SRFB Grant Regional Application Materials

Mill Creek Fish Passage Project

Chelan County Natural Resources Department
411 Washington Street Suite 401
Mike Kane
PRISM # 18-1824

Comments

Figure 5. 30 % plans

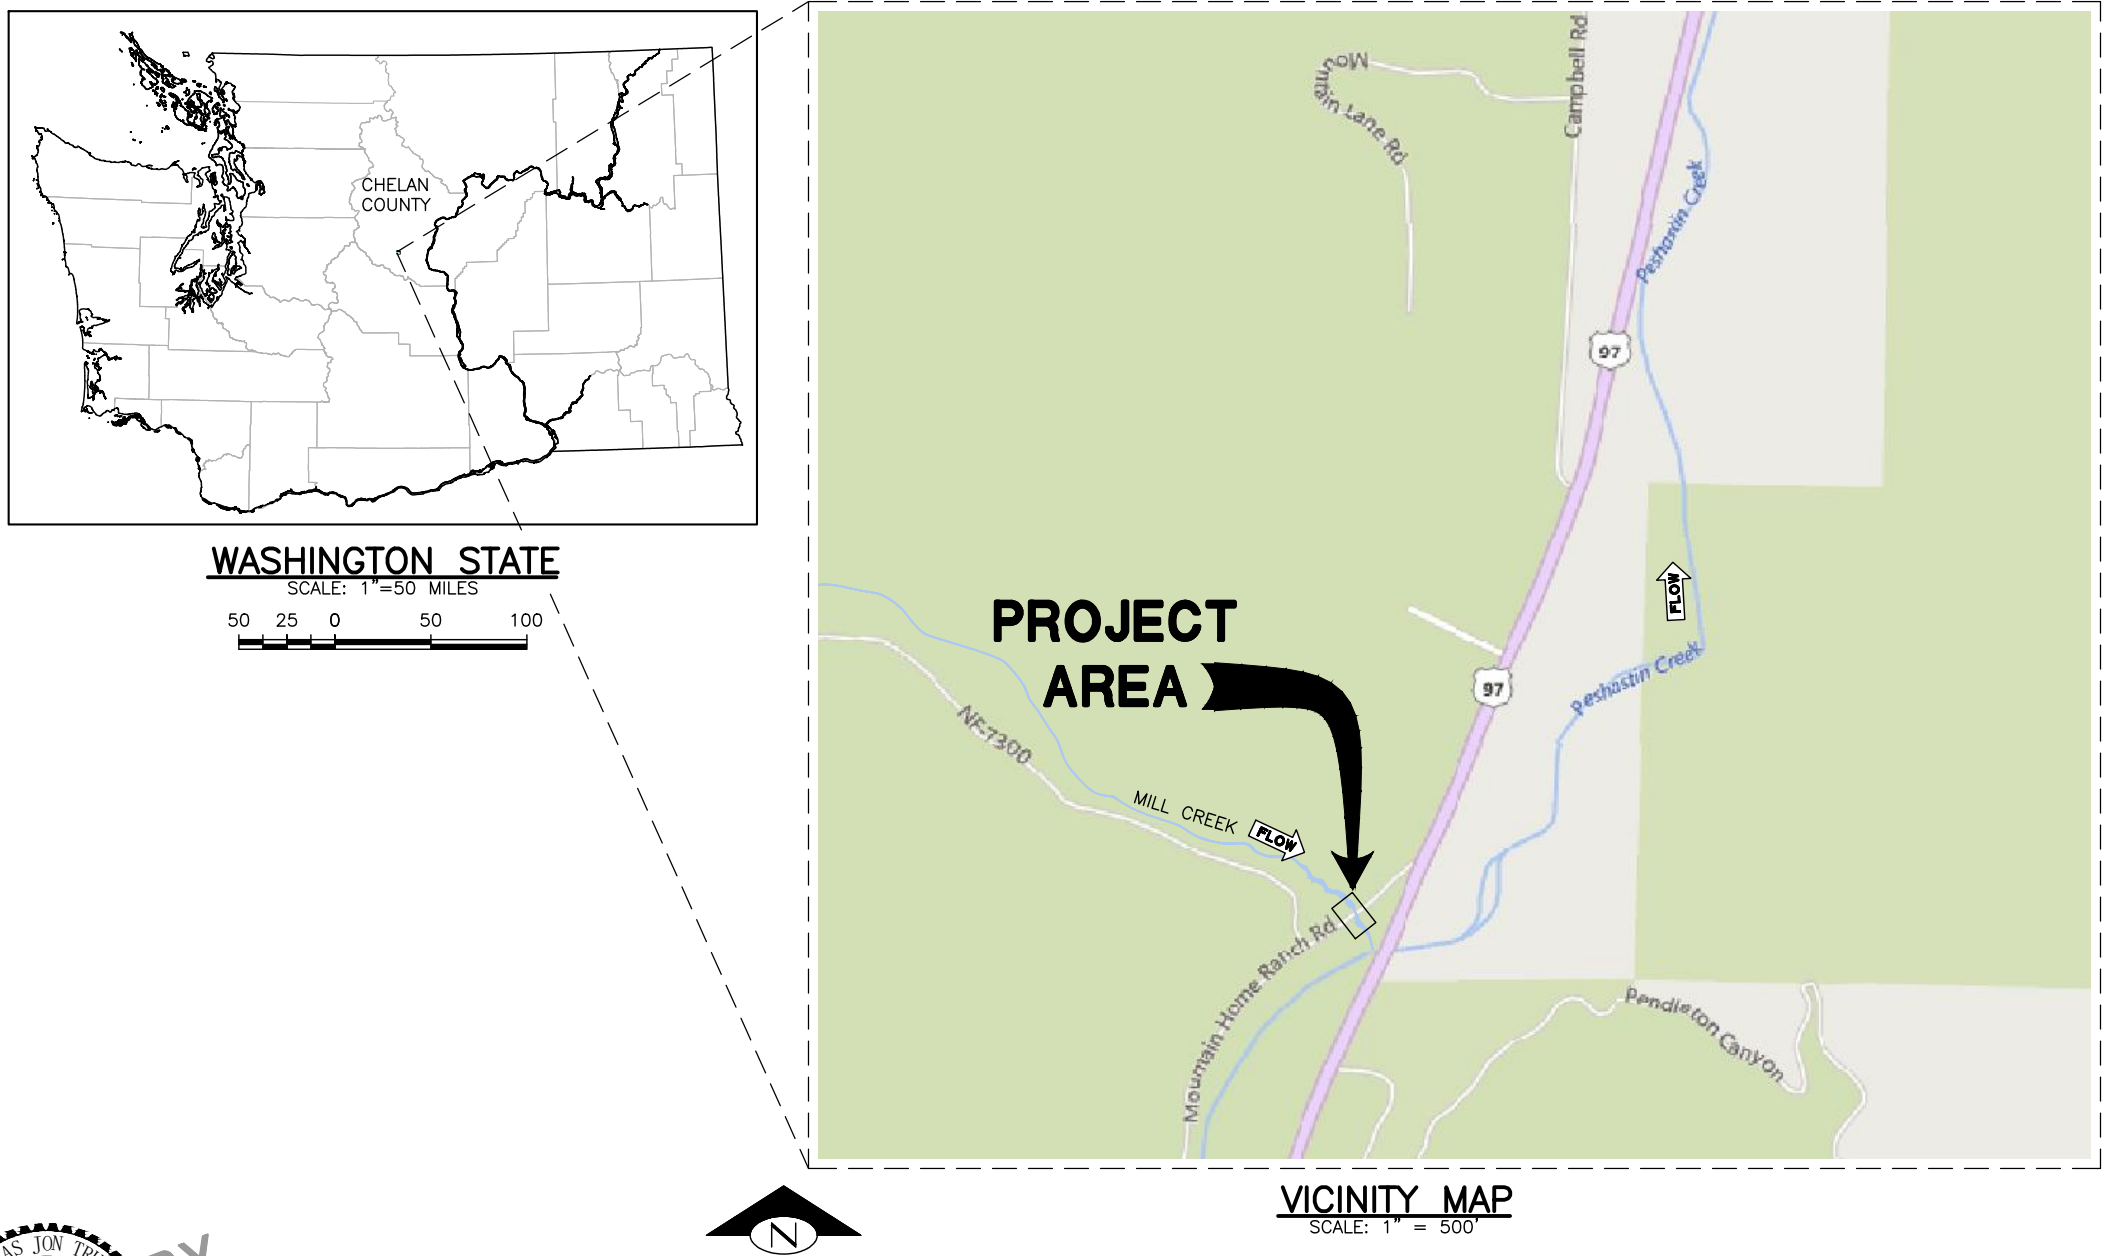
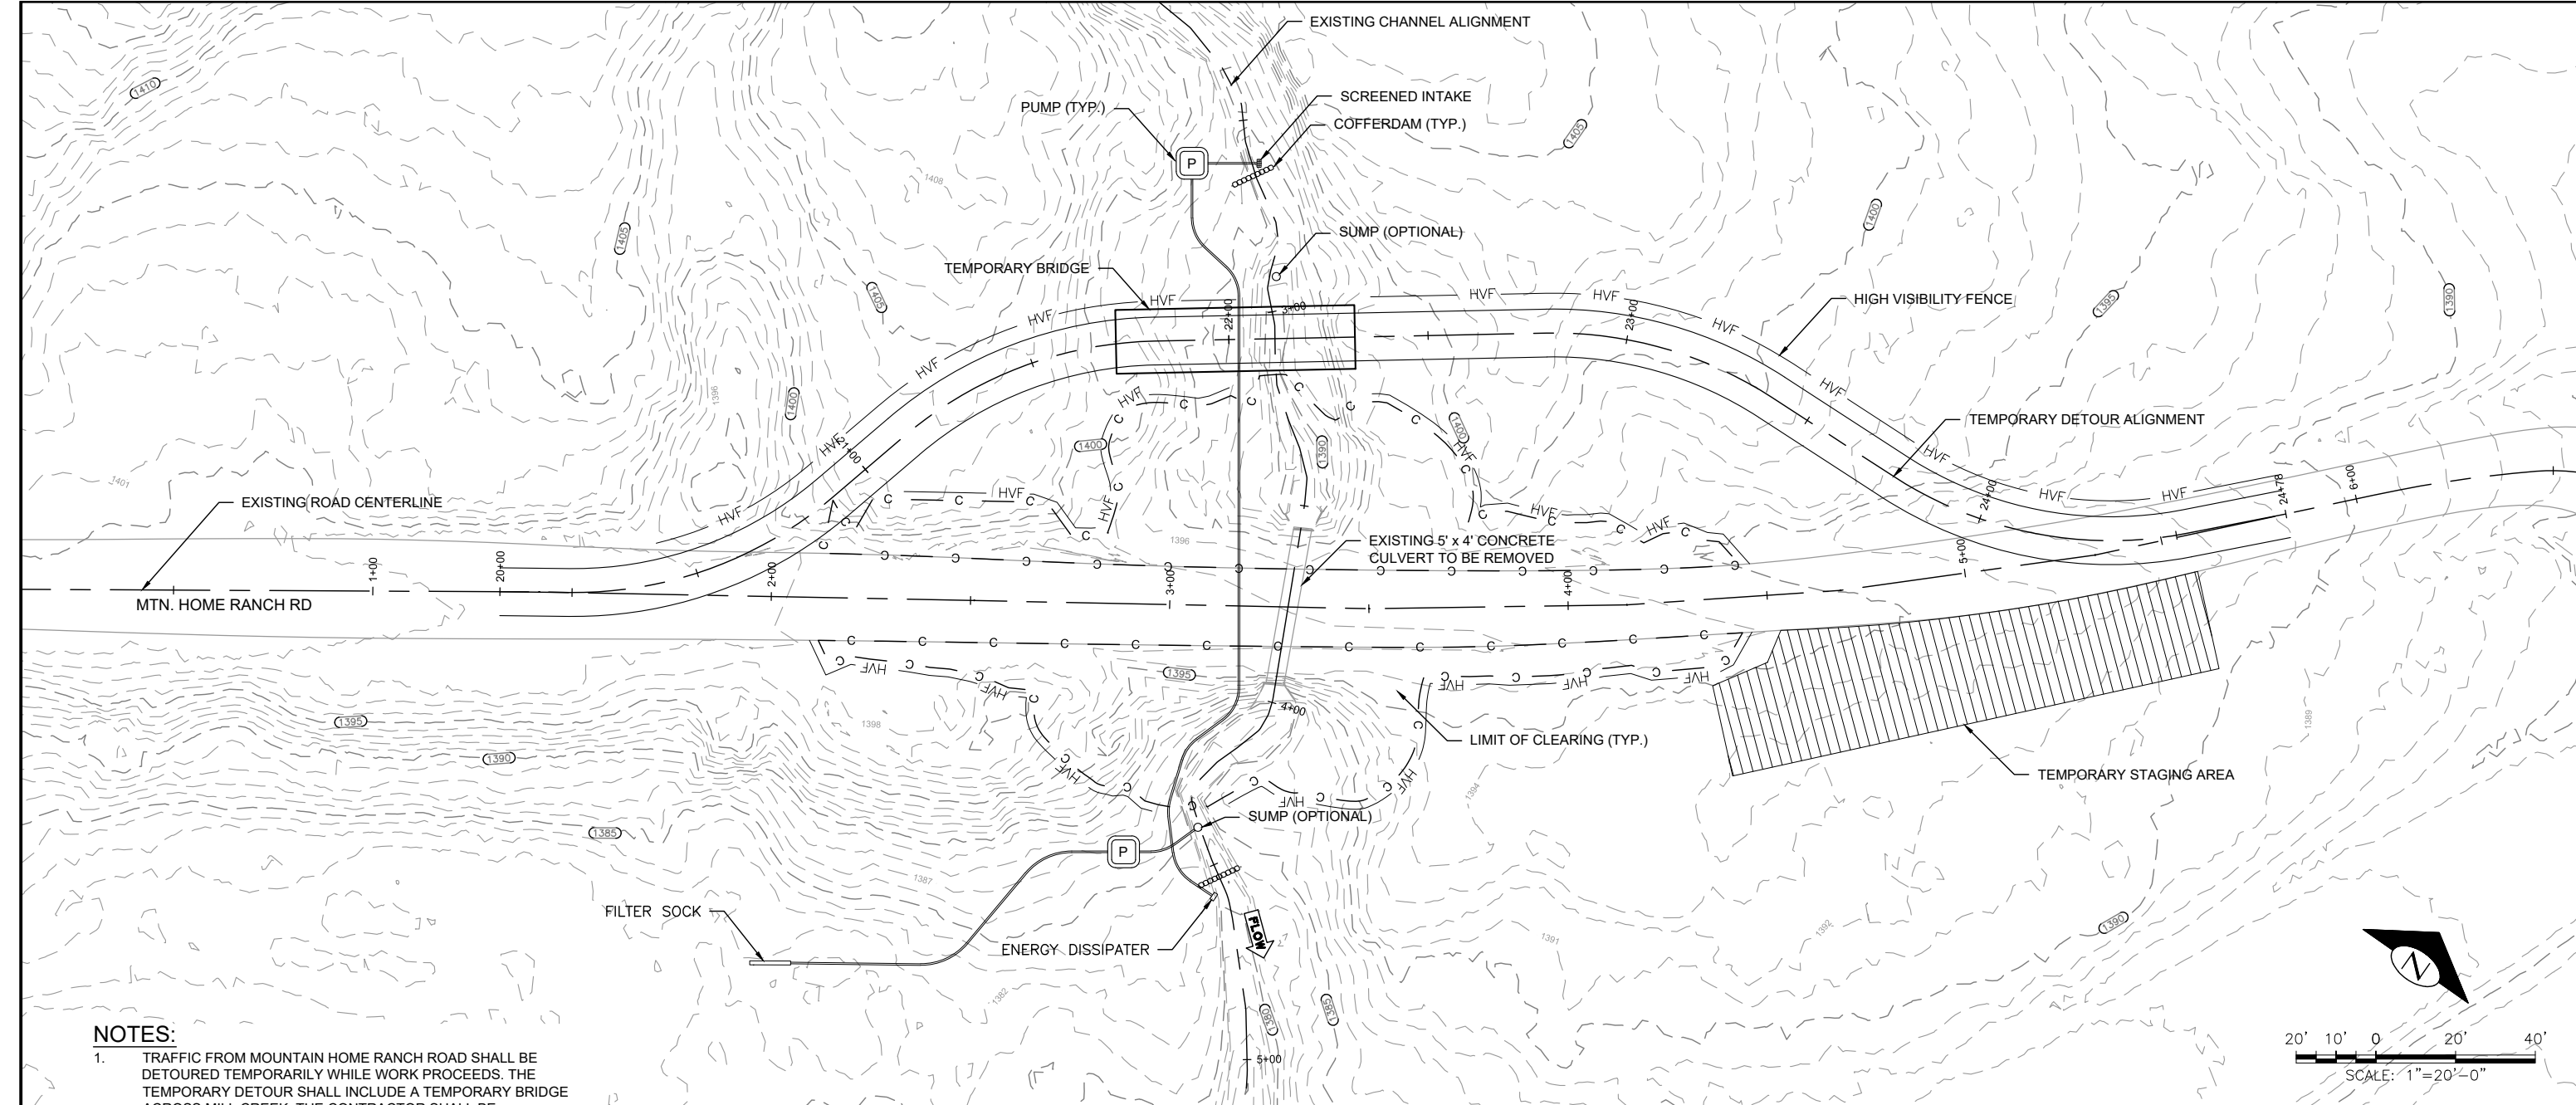
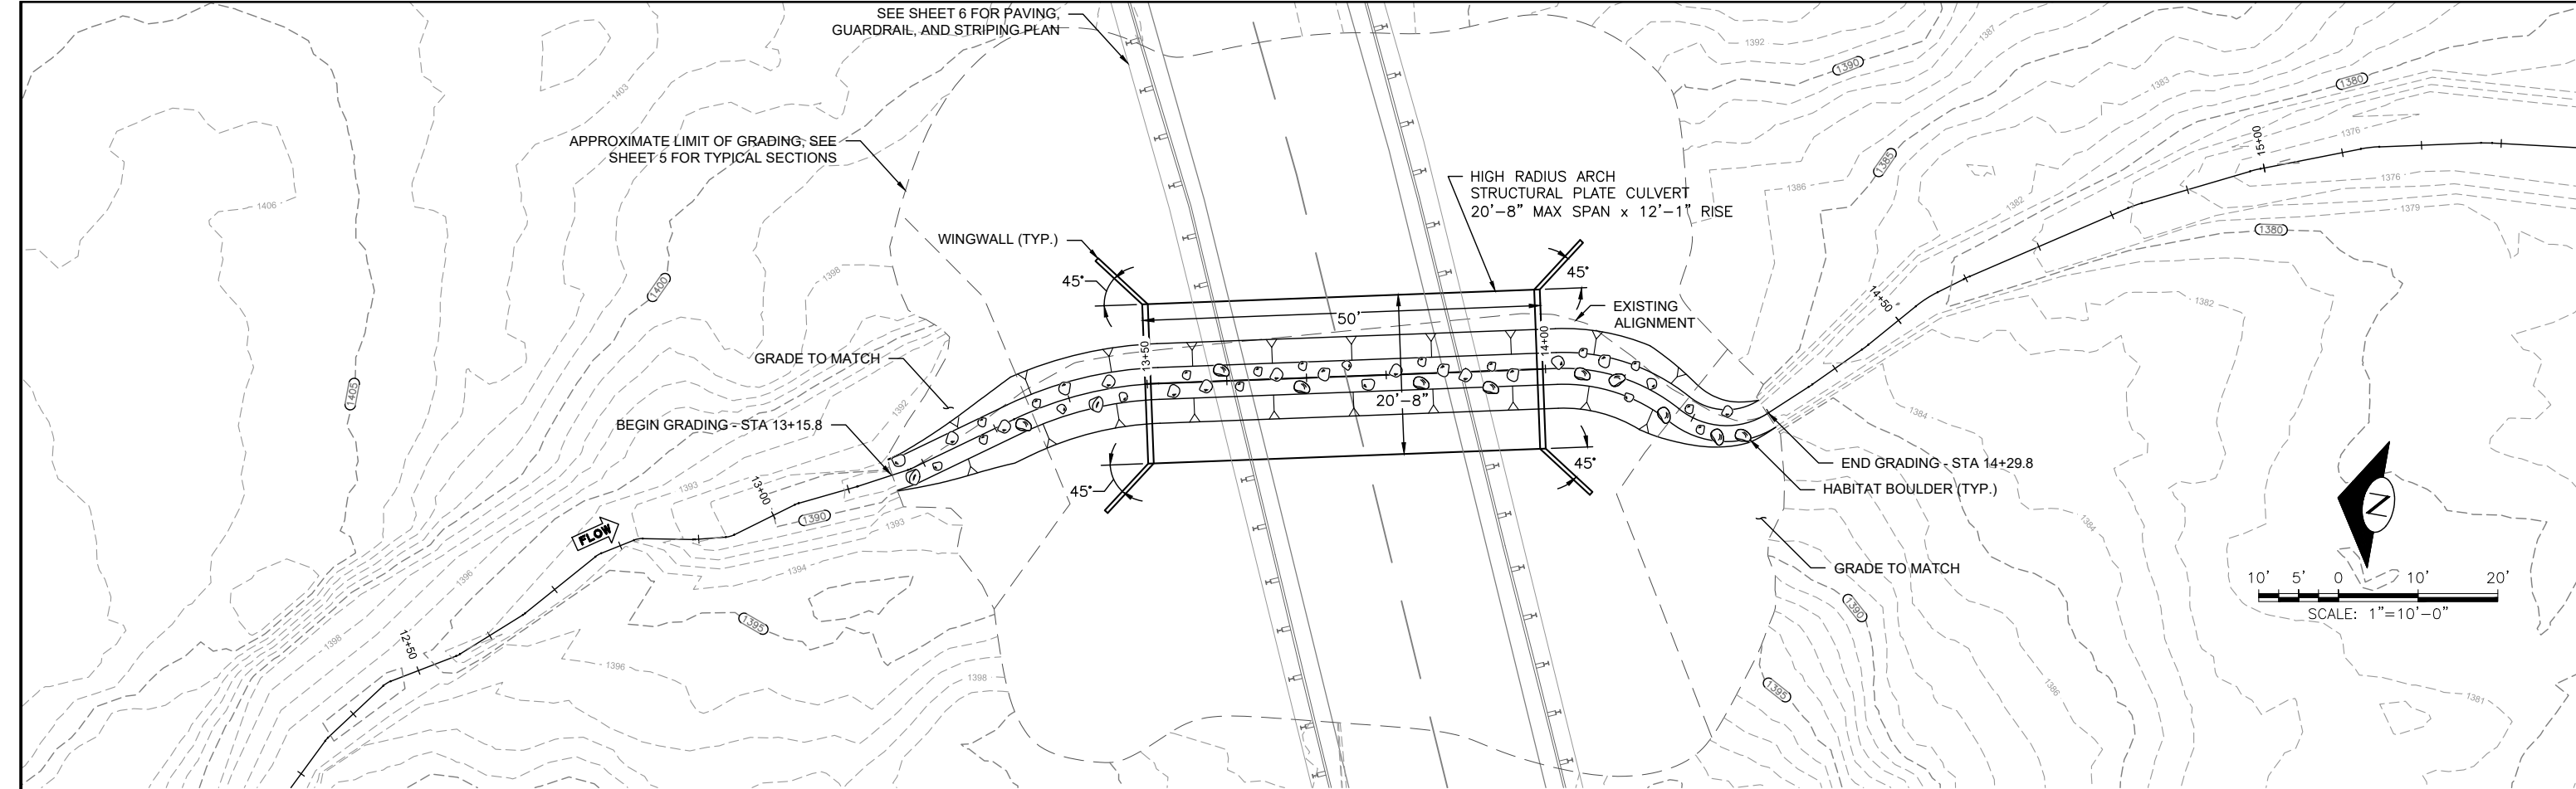
The proposal references "current 30% design"; please load this to PRISM. Preliminary designs and a basis of design (BOD) report that meet the criteria identified in Manual 18 Appendix D will need to be posted on PRISM before final application. The BOD report should include a discussion of the alternatives considered and the rationale for the preferred selection. If this will not be feasible, the grant should be for design and permits, without construction. The cost estimate shows nice detail on construction costs but should also include match and show the total project cost.

The proposal highlights the potential for debris flows to occur in the basin and the increased span and footing depth for the proposed drainage structure to accommodate sediment deposition and minimize scour impacts. While a nearly 21-foot wide corrugated arch pipe with about 12 feet of clearance may accommodate smaller debris flows, most debris flows contain a fair amount of woody debris that typically will plug even the largest of culverts. Increasing the size and clearance of the arch pipe may in this case just be adding costs to the project without providing meaningful protection from debris flows. The project design should focus on maintaining the stability of the crossing and allowing for maintenance access to clean out the structure in the event of a debris flow. The culvert inlet should also be mitered to increase its capacity and lessen the impact of woody debris piling up.

"Figure 5" of this document is the complete set of 30% design plans. 60% preliminary designs have not been completed.

The design team has included total project cost and anticipated match from FBRB for this project, but does not have a completed a basis of design report at this time and does not have current funding to complete prior to the final PRISM submittal. The sponsor has reduced the ask from SRFB to \$131,476 (21%).

The design team is willing to consider various design options including a bridge while completing preliminary designs, but accommodating the concerns of Chelan County Public Works and the adjacent landowner will remain a high priority in that process. The design team is definitely focused on maintaining the stability of the crossing and access for maintenance will be possible post-construction. The sponsor would be willing to work with the SRFB Panel to address debris flow concerns while maintaining a cost effective project.
